## DESCRIPTIVE REPORT

Registry No. .... **H-11201**

General Locality ..... **Approaches to Prince William Sound**

## Revisions Compiled During Office Processing and Certification

Figure 1 H11201 Survey Limits

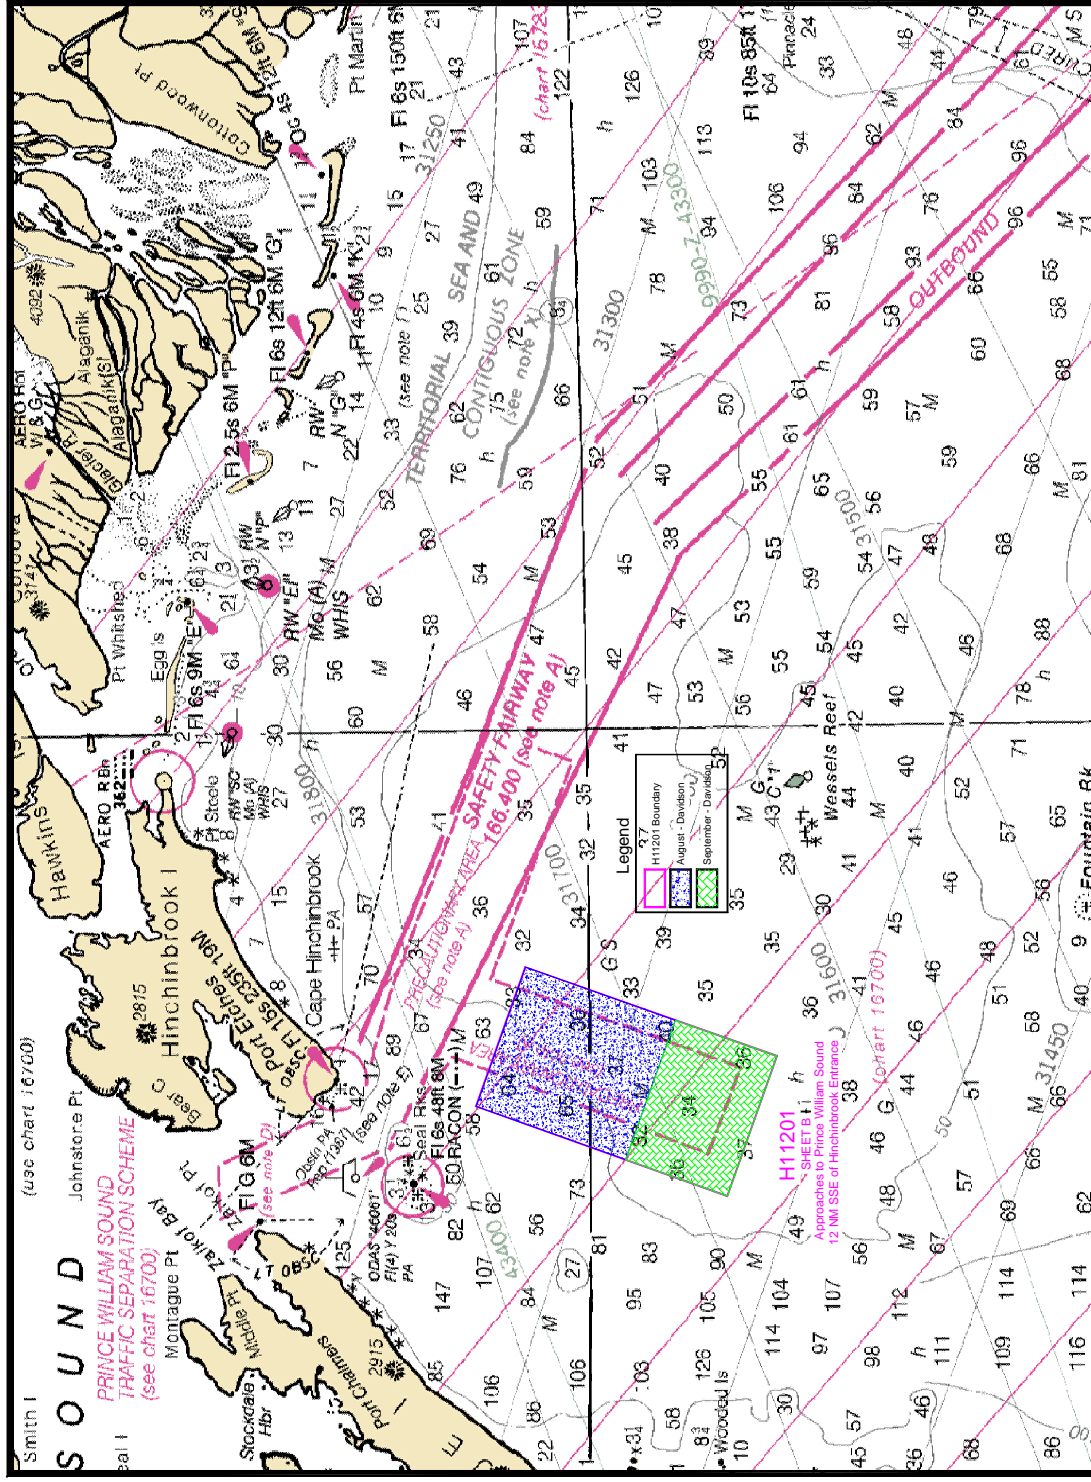
**Table 1 H11201 Survey Limits<sup>1</sup>**

- <sup>1</sup> Revise sheet limits to the following:
  - 60/06/37N, 146/39/30W (North)
  - 60/04/11N, 146/26/17W (East)
  - 59/50/24N, 146/36/11W (South)
  - 59/52/49N, 146/49/29W (West)
- <sup>2</sup> Filed with the Project Records.
- <sup>3</sup> Concur.
- <sup>4</sup> PHB Revision--Strikethrough ~~SE~~ and insert NNW
- <sup>5</sup> PHB Revision--Strikethrough ~~SW~~ and insert NE
- <sup>6</sup> Concur.
- <sup>7</sup> Filed with the Project Records.
- <sup>8</sup> Concur.
- <sup>9</sup> Concur.
- <sup>10</sup> Concur.
- <sup>11</sup> Concur.
- <sup>12</sup> Concur.
- <sup>13</sup> Concur.
- <sup>14</sup> Concur with clarification. Some bottom samples were retained from Chart 16700. Chart bottoms samples as shown on the Hdrawing.
- <sup>15</sup> Filed with the Project Records.
- <sup>16</sup> Filed with the Project Records.

**Figure 3 H11201 Survey Junctions**

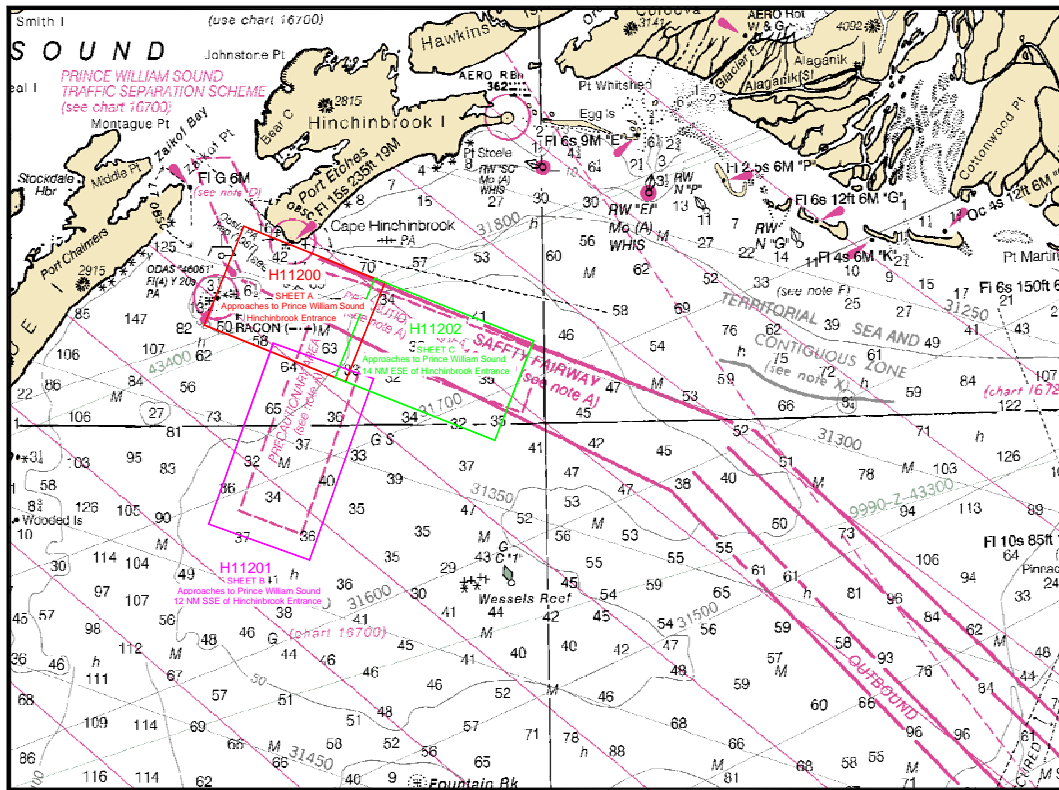
Registry #	Scale	Date	Junction Side
H11200	1:20,000	2003	SE Corner <sup>4</sup>
H11202	1:20,000	2003	SW Corner <sup>5</sup>
